Deer Mountain Resort Lot 35 storm drain easement Minor Plat Amendment

Project: PlatAm-26-002 | Lot 35 Deer Mountain Resort
Report Date: 11 May 2026
Report Author: Doug Smith, Planning Director
Council Action Required: No
Type of Action: Administrative

Applicant: Mike Johnston
Address: 12708 Slalom Run Drive
Zone: Mountain (M) JBOZ
Existing Plat: 120' wide storm drain easement
Proposed Amendment: 40' wide storm drain easement

Exhibit B – Existing Subdivision Plat

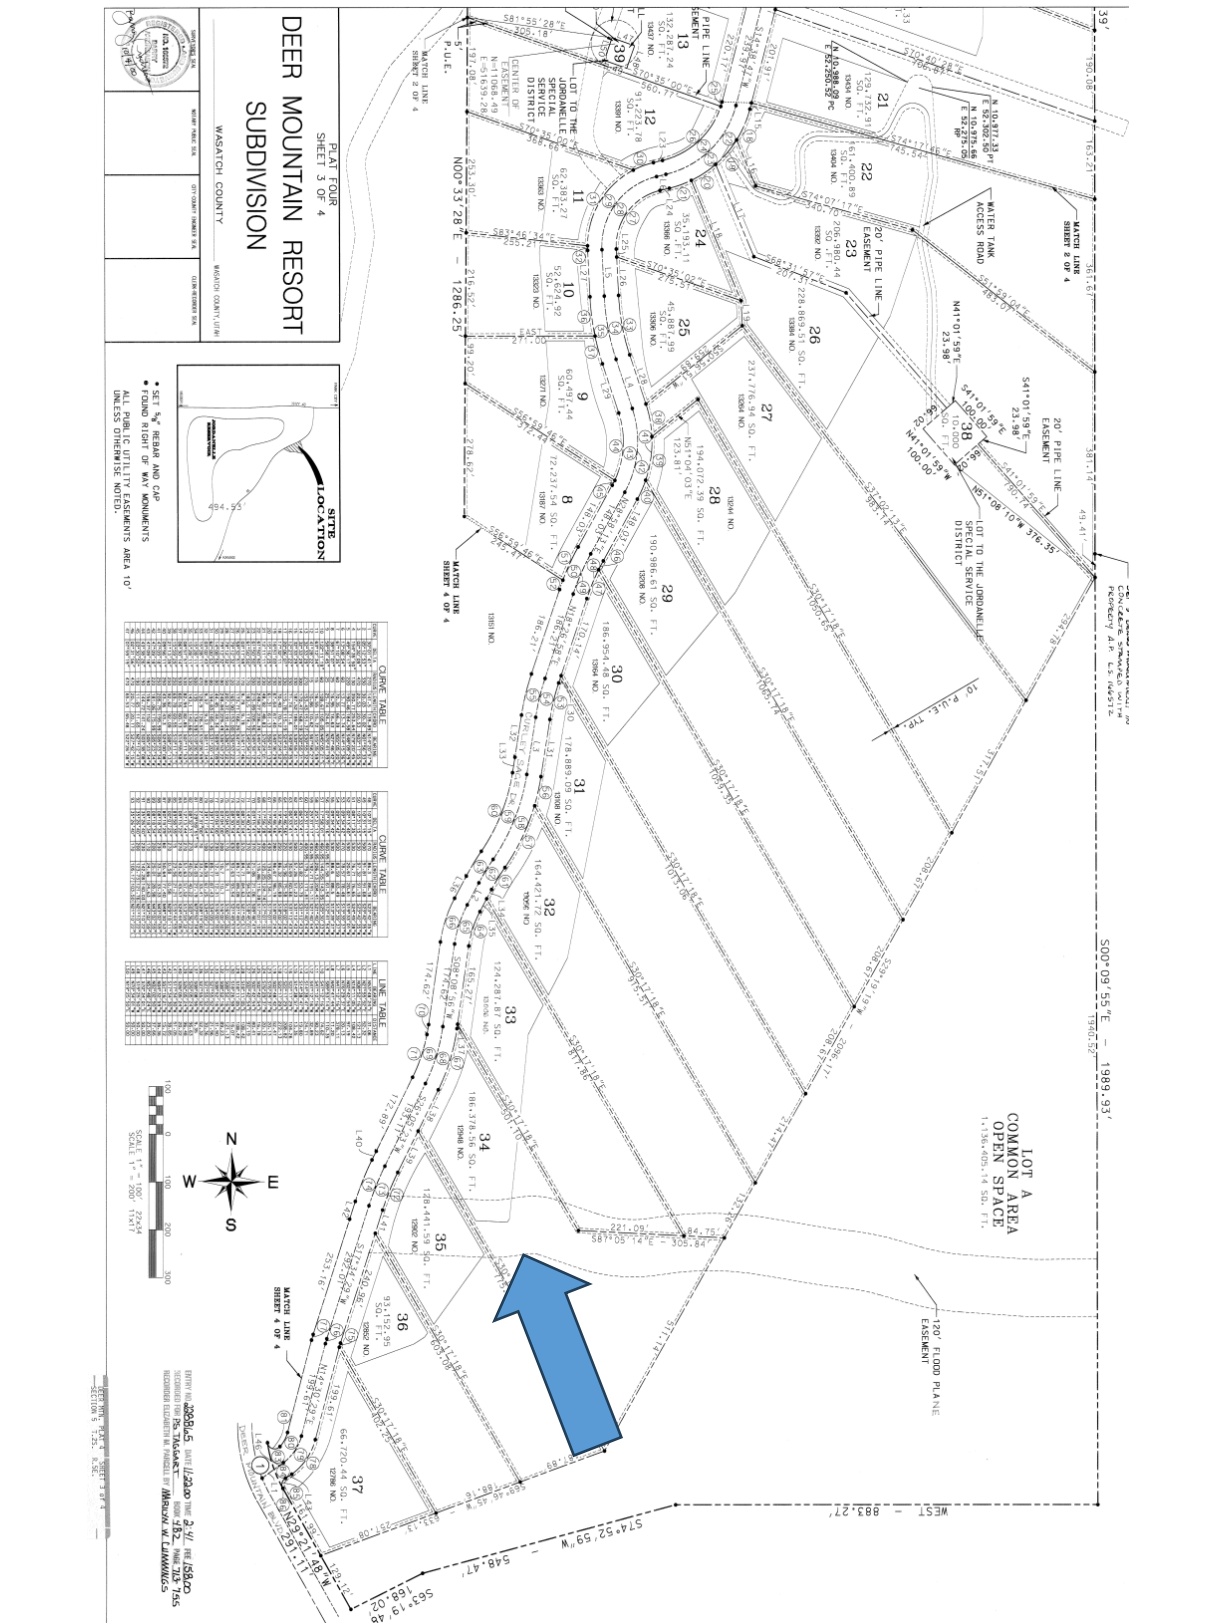
The recorded plat for Deer Mountain Resort Plat 4 (recorded in 2001) shows a 120-ft wide “Floor Plane” [sic] easement on the drainage gully as it runs through the middle of the lot.

This 120-ft easement for flooding is excessive and basically makes the building envelope unbuildable for a house typical to the neighborhood. This application for a plat amendment is to eliminate the 120-ft Flood Plain easement and replace it with a 30-ft Storm Drainage Easement.

It seems likely that no storm water runoff calculations were done in 2001 when the Deer Mountain Resort plat was designed, and some junior engineer guessed that a 120-ft wide easement would be “adequate” to pass the 100-year storm event. The odd thing is that someone probably did design the 48” dia. RCP culverts that pass storm water under the roads as it moves down the gully. Calculations for the max storm water flow down the actual channel show the flow to be 57 cfs, which does fit nicely through the 48” dia. pipes and fills the “V” gully roughly 20” deep x 7-ft wide. Calculations for the max 100-year storm event with the highest flow rate are attached hereafter.

This requested plat amendment reduces the storm water easement crossing the lot to be 30-ft wide, which roughly follows the existing rock riprapped gully, and gives a horizontal buffer of over ten feet each side of the flow line. This new easement width will give an extra 45-ft on each side of the gully for a house to be built within the original Building Envelope. Any driveway that may cross the gully will need to use a 48” dia. RCP pipe for the culvert.

Exhibit C – Proposed Amended Plat

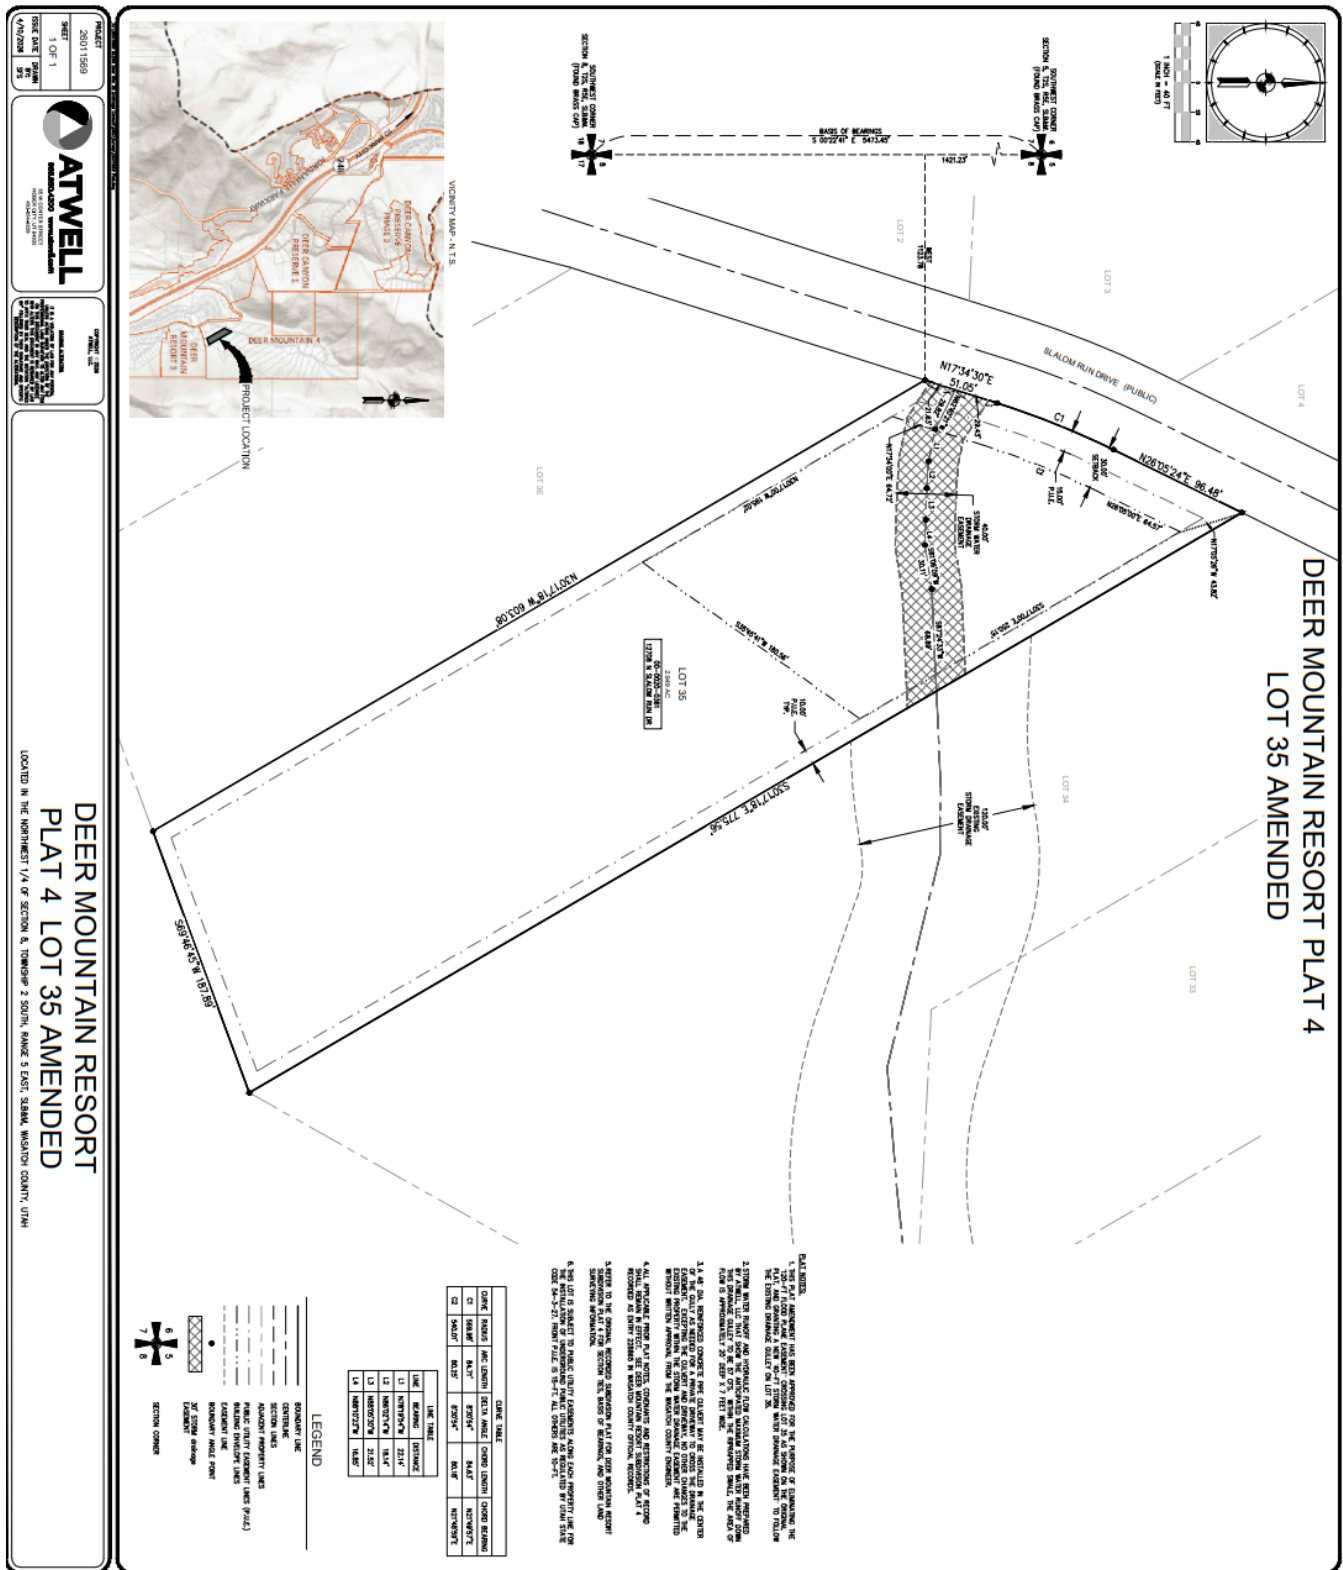
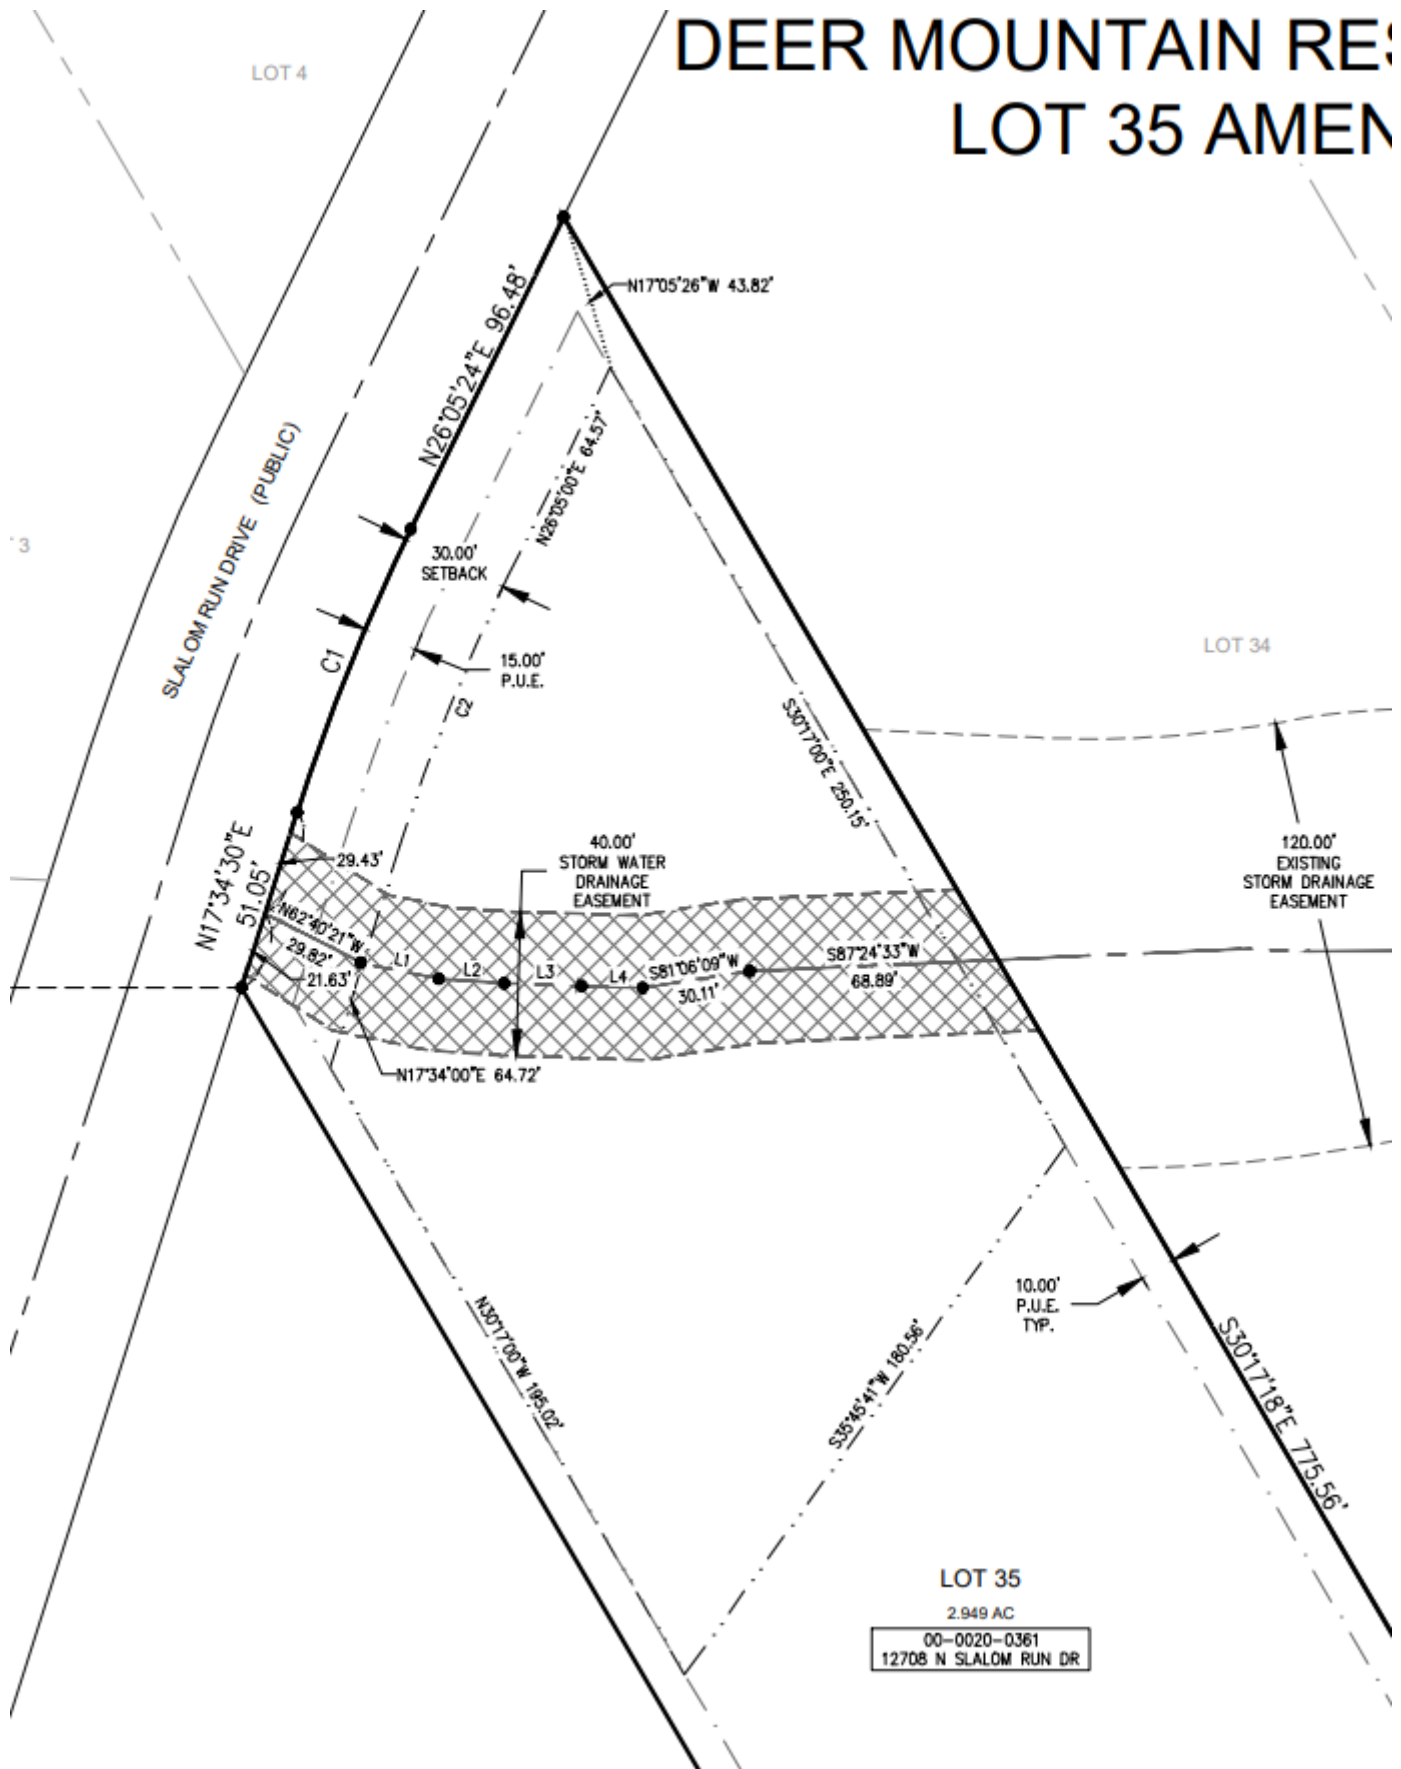
Engineering			
Item	Comments		
Letter of Request	04/02/26 - Devin Earl	- Rejected	- The existing channel has a width of at least 20-feet - See additional Notes
The existing channel has a width of at least 20-feet in a few places and a 30-foot easement would hardly provide any additional room for access if maintenance, cleanout, or repair is needed. The downstream easement is 60-feet. Recommended to increase total easement width to 40-feet (20-feet each side of drainage centerline) to help facilitate access and maintenance if needed. Otherwise agree with reasoning for plat amendment.			
Proposed Plat	04/02/26 - Devin Earl	- Rejected	- Please revise easement to be 40-feet wide to allow - See additional Notes
Please revise easement to be 40-feet wide to allow for 20-feet each side of drainage centerline to accommodate space outside the existing rip-rap for access to maintain or repair drainage if needed. Please submit hydraulic calculations as referred to in Plat Note No. 2.

Planning			
Item	Comments		
Other			
The Wilding letter states that the drainage is not a Stream Corridor as defined with the following definition. STREAM CORRIDOR: Any river, stream, pond, lake, or wetland, together with adjacent upland areas, that supports protective bands of vegetation that line the waters' edge.			
Proposed Plat			
The drainage is NOT in a FEMA floodplain. As such it is regulated by code section 16.28.04 No dwelling, addition or other building used for human habitation shall be constructed within fifty feet (50') of the high water mark of a stream corridor except after a conditional use permit has been authorized by the planning commission. "High water mark of a stream corridor" as used in this section means that point on the bank or shore up to which the presence and action of surface water is too continuous as to leave a distinctive mark such as by erosion, destruction or prevention of terrestrial vegetation, predominance of aquatic vegetation, or easily recognized characteristics. The planning commission shall not authorize a permit therefor unless the following can be shown: Is it possible to meet the 50' setback and have the needed building envelope?

Proposed Plat			
- The street name is spelled wrong. - The note refers to this as a flood plain. It is not a FEMA regulated channel. - Please refer on the note to a storm drainage easement. - The rip rap is 30' wide. The easement should be 50' wide in case there ever needs to be repair done on the rip rap.			
Proposed Plat	04/02/26 - Doug Smith	- Rejected	- Current code requires a 15' front PUE. - The r - See additional Notes

- Current code requires a 15' front PUE. - The road labeled in the front is misspelled - Please change the note on the plat to storm water not flood plain. This is not a flood plain. - Due to the need to maintain the rip rap we recommend that a 40' easement be noted on the plat.			
Fire Department

We have increased the storm drainage easement to 40-ft wide, as requested

We have increased the storm drainage easement to 40-ft wide, as requested

The entire reason this plat amendment was requested is to recognize that gully is a drainage easement and NOT as stream. There is NO SETBACK required from this gully. The 40-ft easement is sufficient for safety and for maintenance.

Street name corrected. As requested, we have changed the easement crossing the other lots to be a "Storm Drainage Easement."

15' front PUE shown. Street name corrected. As requested, we have changed the easement crossing the other lots to be a "Storm Drainage Easement."
